5/8 "CAPE DREPANON"

PROPOSED MODIFICATIONS TO STRUCTURE
IN WAY OF NP 3 HOLD

VEROLME CORK DOCKYARD LIMITED

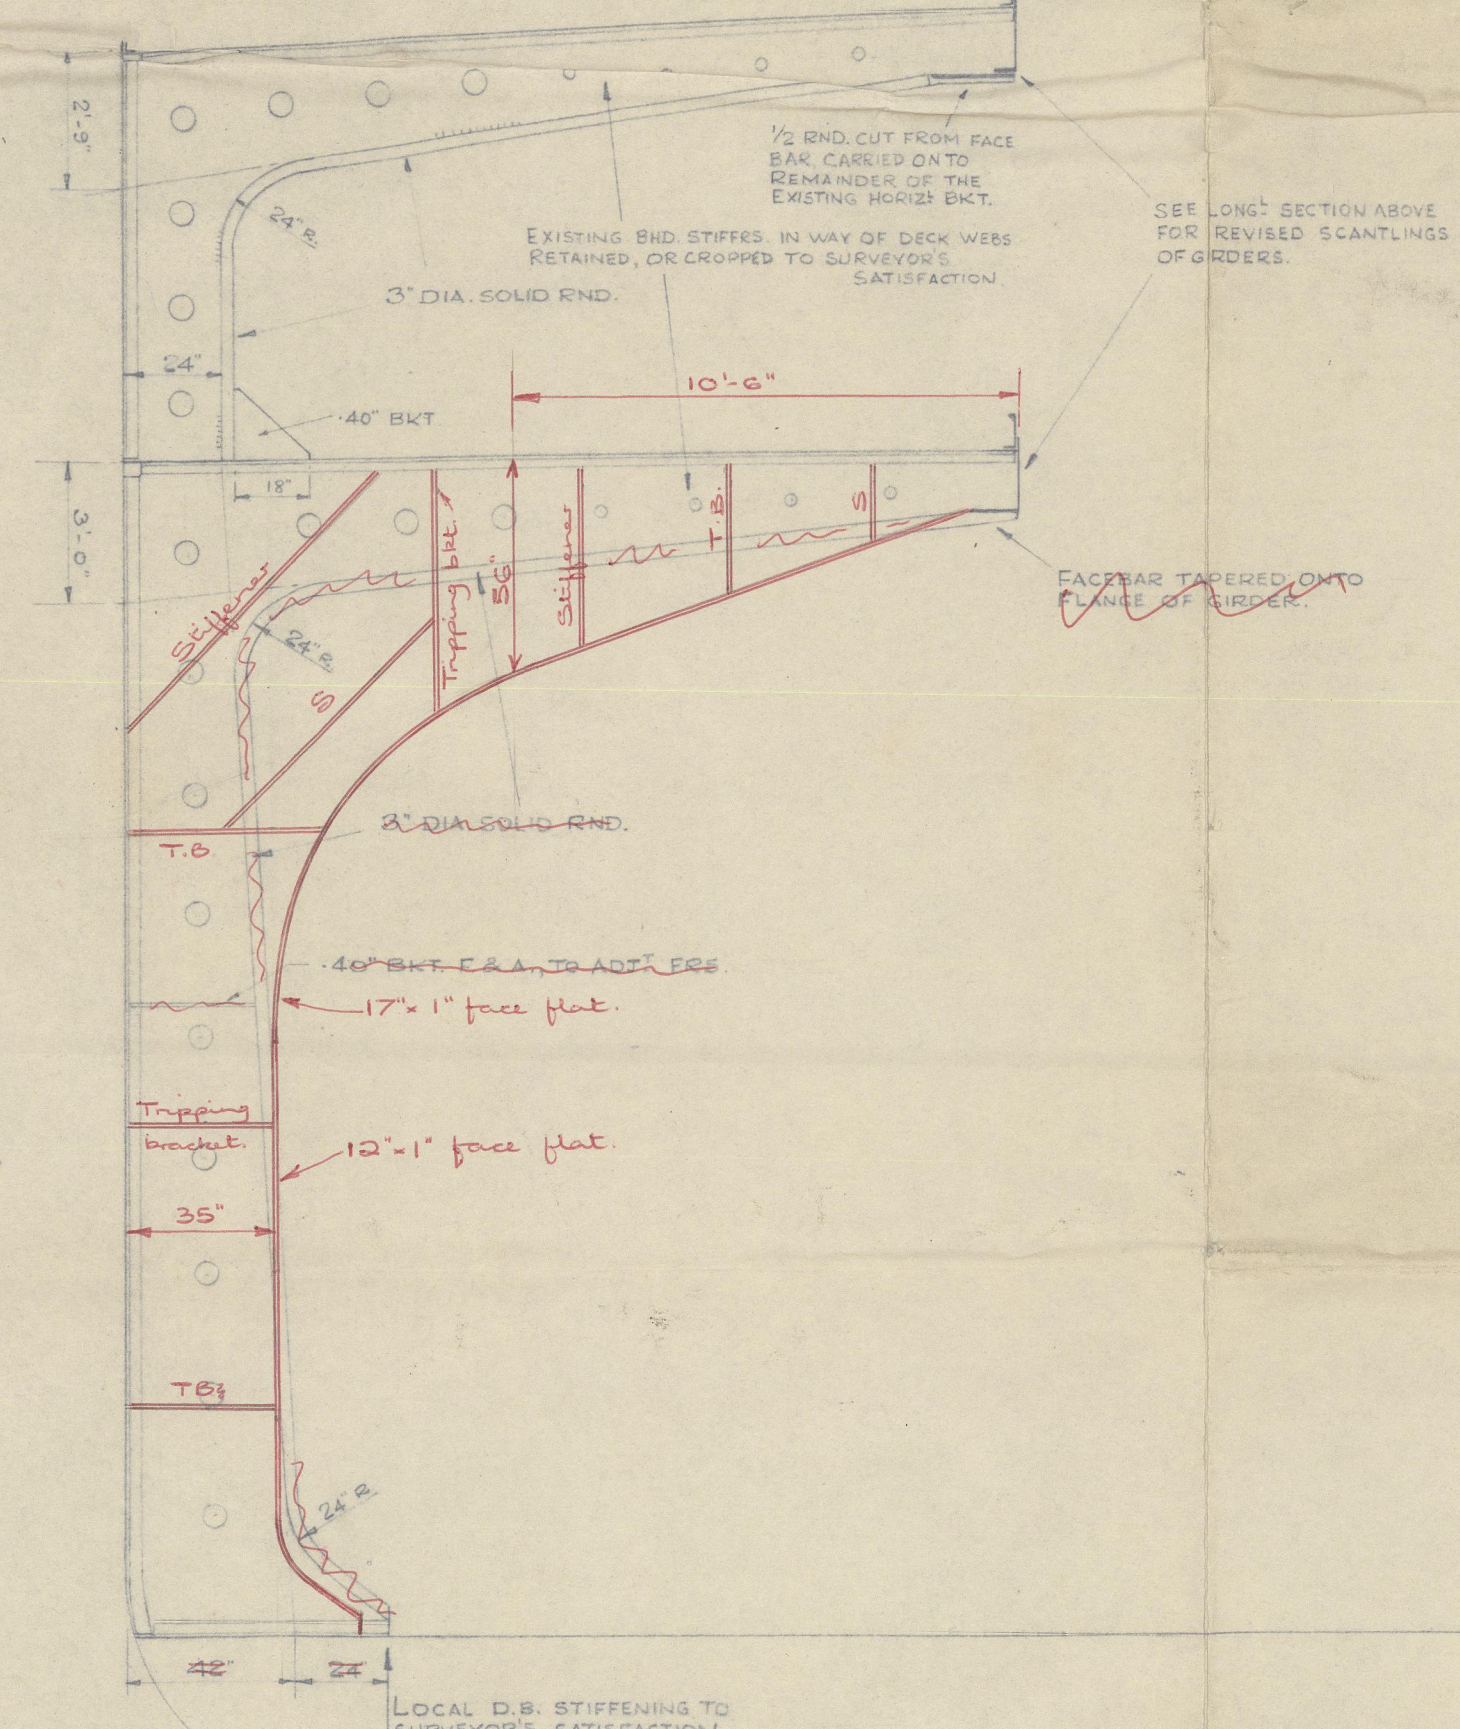
✓ Existing structure may ^{also} be used without alteration

WEB FR. TO PROVIDE ~~PARTIAL~~ GDR. SUPPORT ONLY

G.H.W
3.11.60
